3 Revisions to the GP Draft EIR/ Pier Draft EIR/EIS

This chapter presents specific text changes made to the Draft EIR/EIS since its publication and public review. The changes are presented in the order in which they appear in the original Draft EIR/EIS and are identified by the respective page number. Text deletions are shown in ~~striketrough~~, and text additions are shown in underline.

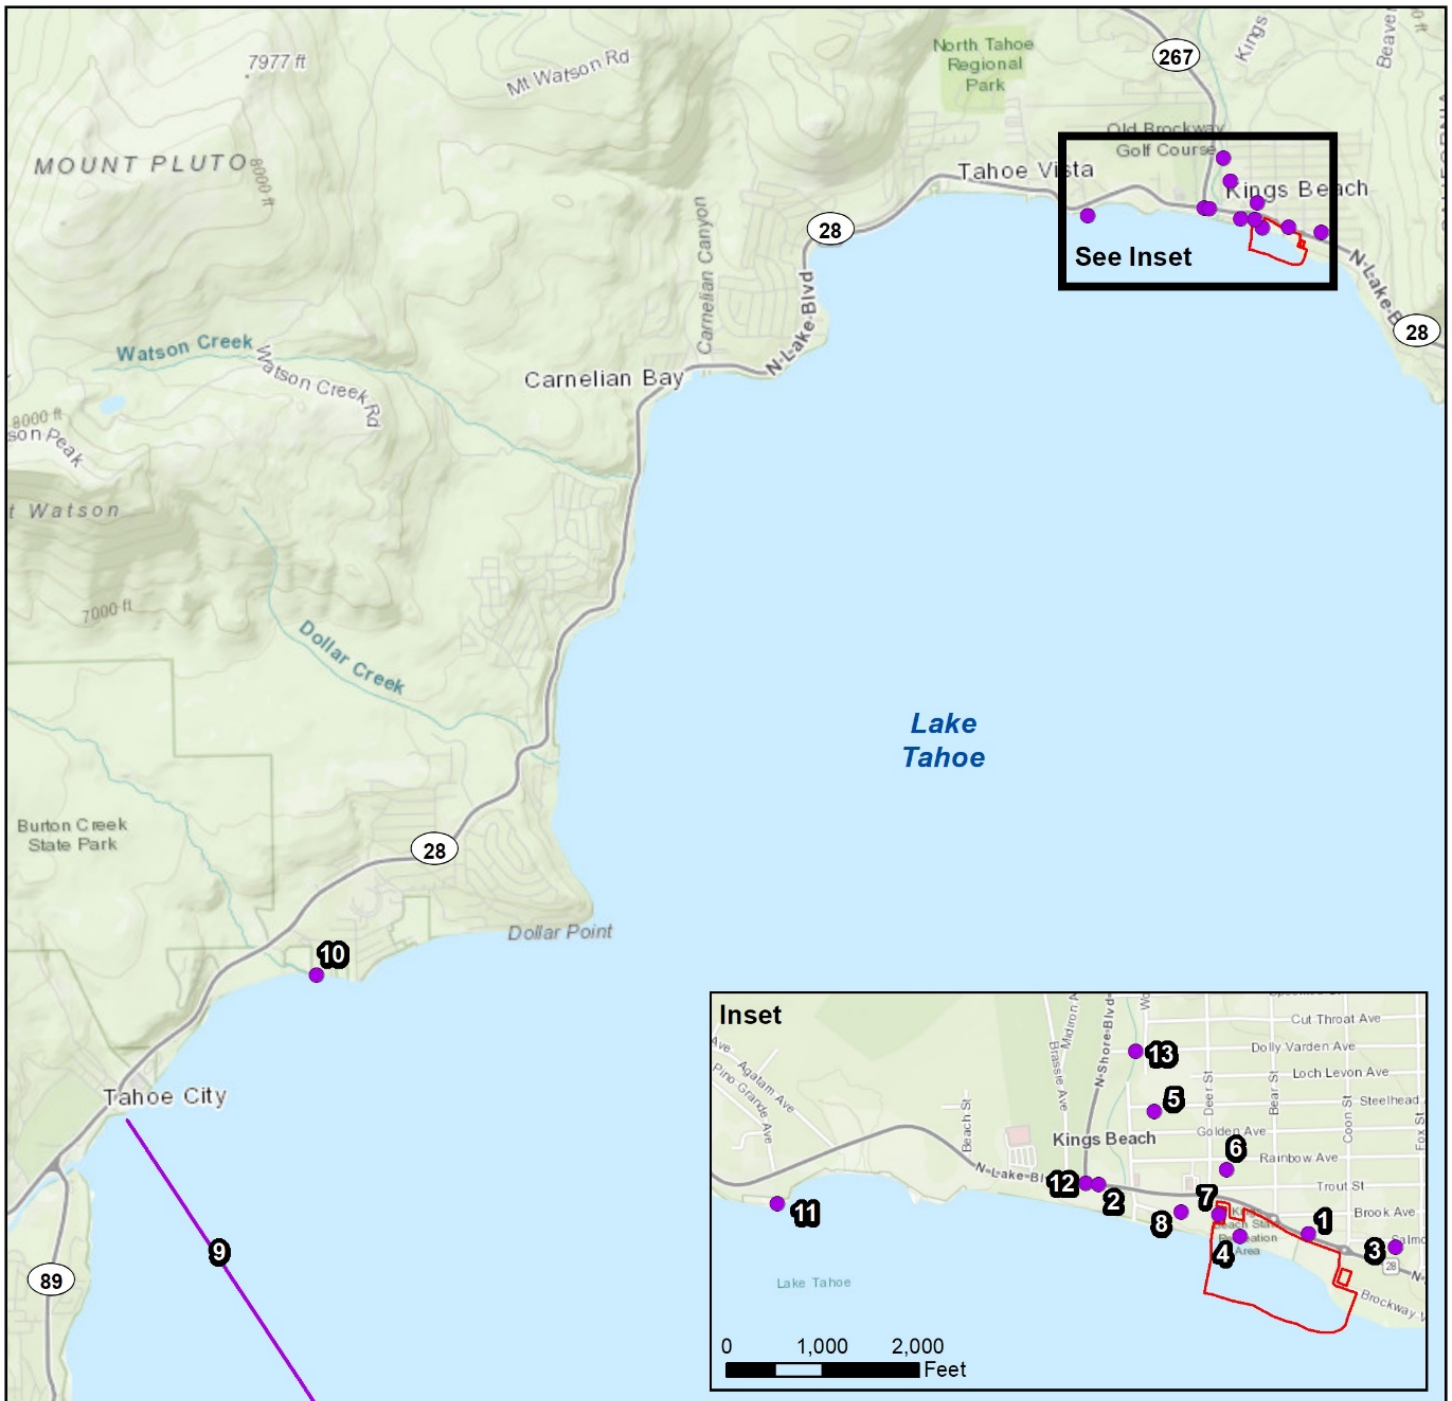
Portions of Table 5.1-4 beginning on page 5-32 and Exhibit 5.1-15 on page 5-36 in Section 5.1.3, Contents of Environmental Analysis Sections, are revised as follows:
